Proposal for revision of the document ECE/TRANS/WP.29/GRPE/2012/2

The document ECE/TRANS/WP.29/GRPE/2012/2 was further discussed with the experts from the United Kingdom, the Netherlands and the European Commission. The outcome of the discussion is a revision of the above mentioned document. In the revised document the wording of some paragraphs was improved for better clarification. Further the following points are changed:

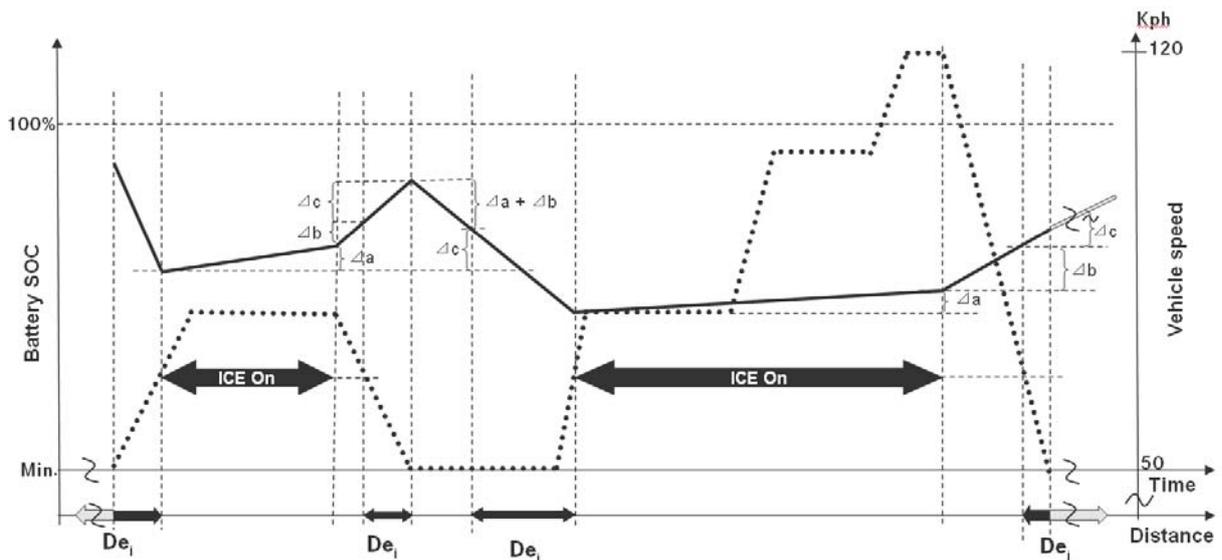
During this procedure, the electricity balance (Q_{ESi}) of the high voltage battery (expressed in Ampere hours), measured continuously and using the procedure specified in Appendix 2 to the Annex 8 of this Regulation, the vehicle speed (V_{ESi}) and De_i shall be recorded at the instant when the fuel consuming engine starts and the accumulation of De_i shall be stopped. Further accumulation of De_i shall not be permitted unless

- the fuel consuming engine stopped running and
- V_{ESi} has returned to the same or any lower level of V_{ESi} as recorded before the fuel consuming engine started and

- Q_{ES_i} has returned to the same or any lower level of Q_{ES_i} as recorded before the last fuel consuming engine start or, where applicable, to the same or any lower level of Q_{SA_i} as determined in accordance with paragraph 4.2.2.1.3.1.

4.2.2.1.3.1 During the first deceleration phase following each start of the fuel consuming engine, when the vehicle speed is less than the vehicle speed at which the fuel consuming engine started previously

- the distance covered with engine off should be counted as De_i and
- the increase in electricity balance during this period should be recorded (ΔQ_{rb_i}), and
- the electricity balance when the fuel consuming engine starts (Q_{ES_i}) defined previously should be corrected by ΔQ_{rb_i} (hence new $Q_{SA_i} = Q_{ES_i} + \Delta Q_{rb_i}$)

5. If – as foreseen in current regulation - the usage of a fuel consuming engine is allowed for the procedure to determine the electric range of a hybrid electric vehicle, manufacturer might take advantage of using recuperation energy from a higher vehicle speed level that has been provided by the fuel consuming engine or using the fuel consuming engine as electric generator up to this higher speed level. The recuperation/generator energy increases the SOC and the electric range can this way be extended. Therefore, the influence of the fuel consuming engine should be restricted by stopping the accumulation of the electric range until the fuel consuming engine stops running. But also the recuperated/generated energy from the fuel consuming engine needs to be adequately considered. Therefore the level of electricity balance of the high voltage battery is measured continuously and at latest from the moment on when the fuel consuming engine starts first time. The level of electricity balance when the fuel consuming engine starts is recorded. When this or any lower level is reached again, after loading and depleting operations of the high voltage battery, the accumulation of D_e can be continued. Following this approach no advantages can be taken from usage of the fuel consuming engine regarding the determination of D_e .

6. The recuperation energy and the electric range derived from a vehicle speed level that has provided by the battery is regarded using the procedures and formulae under 4.2.2.1.3.1.
